Docket Item # 11 BAR CASE # 2009-0175

BAR Meeting September 2, 2009

ISSUE: Signage

LOCATION: 817 South Washington Street

Figure 3: Sign specifications – front door.

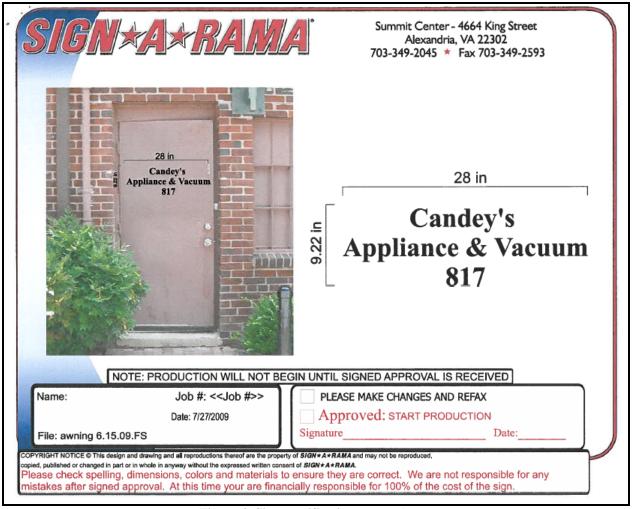
The applicant also proposes signs on the rear alley door and the front door. The back door graphics will identify the business and will measure .7 feet by 2.33 feet. The front door sign will read CANDEY'S OF ALEXANDRIA APPLIANCE AND VACUUM and will include the hours of operation (measuring 2.47 square feet).
